**ADDENDUM NO. 001**

**RE:** Sullivan County Department of Education – Ketron Elem. School Partial Roof Replacement  
T&L Project No. 17118

**DATE:** March 3, 2023

Sheet No.  
**A102**

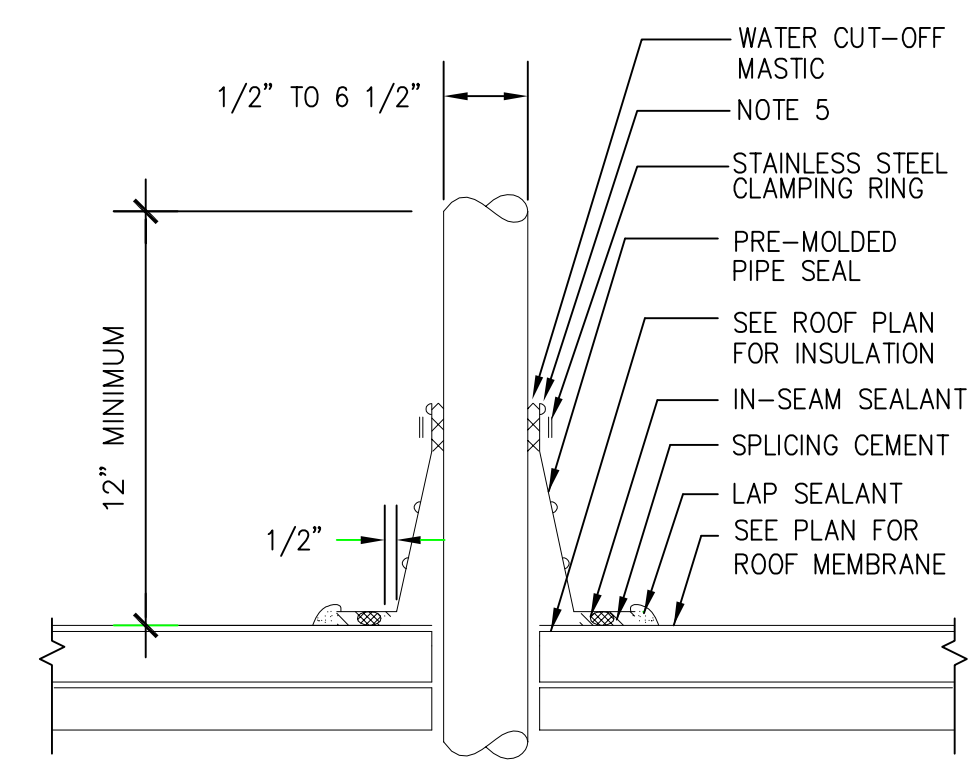
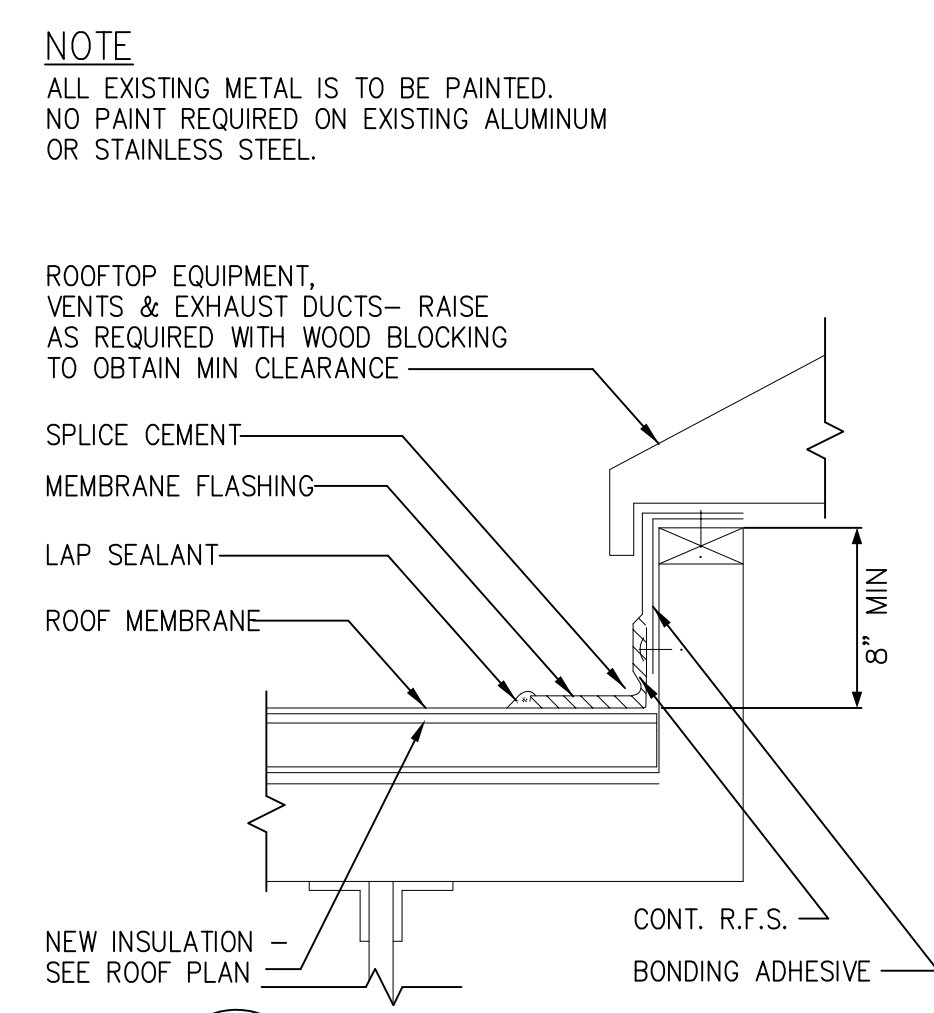
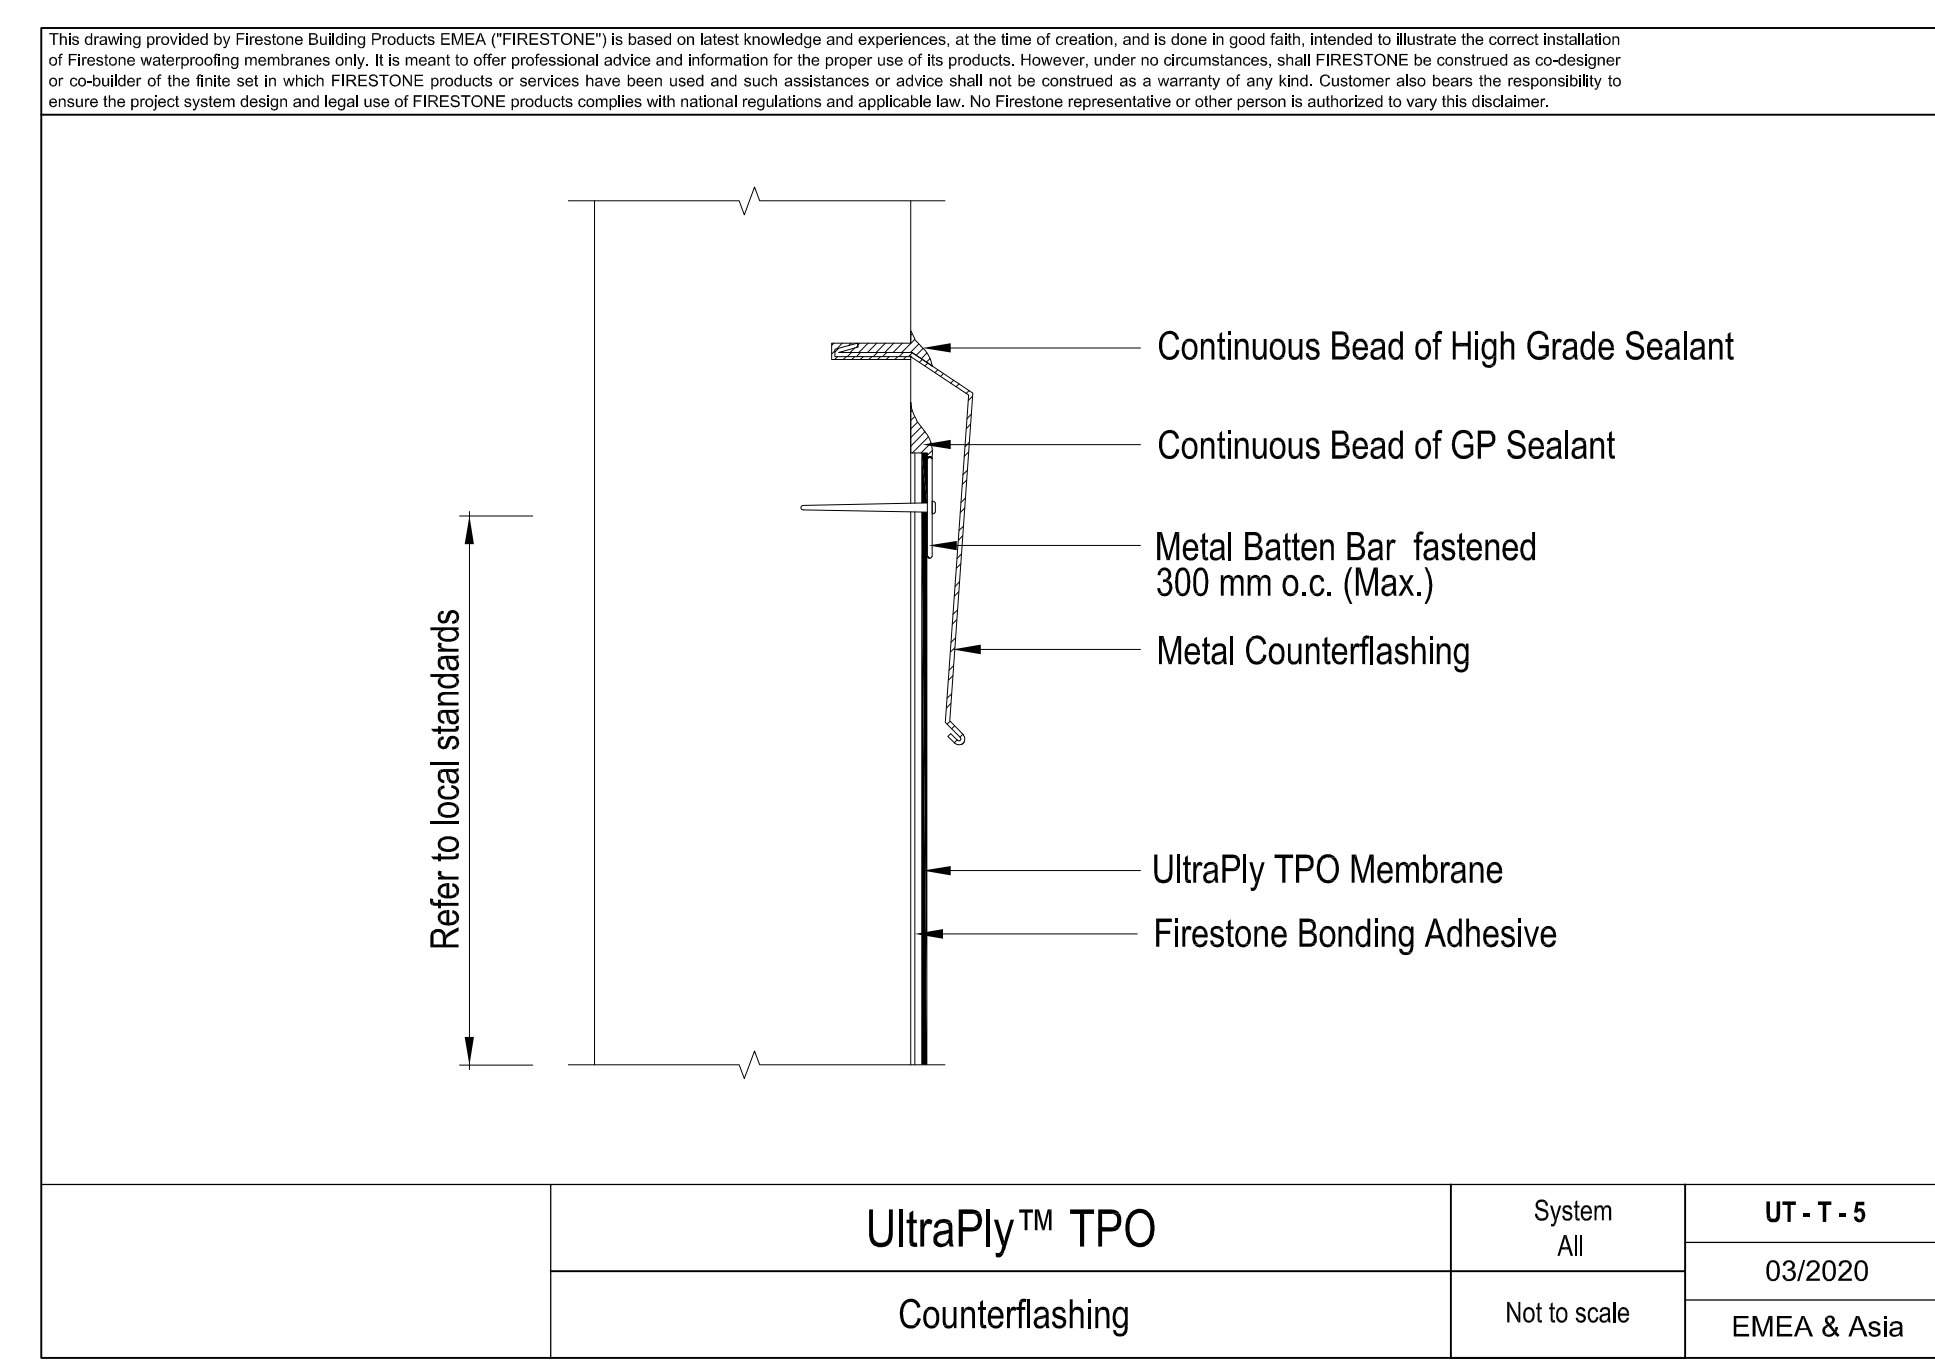
1. Drawing Sheets AD101, A101, & A102 are revised to added alternate #1 with details and notes.

NOTE: PROVIDE BLOCKING FOR ROOF EDGE AS REQUIRED.

4 REGLET DETAIL  
A102 NOTE: VERIFY WEEP VENT LOCATION AND DO NOT COVER.

No.	1	Purpose of Document Issue	ALTERNATE #1 & ADDED DETAILS/NOTES
Date	3/3/2023
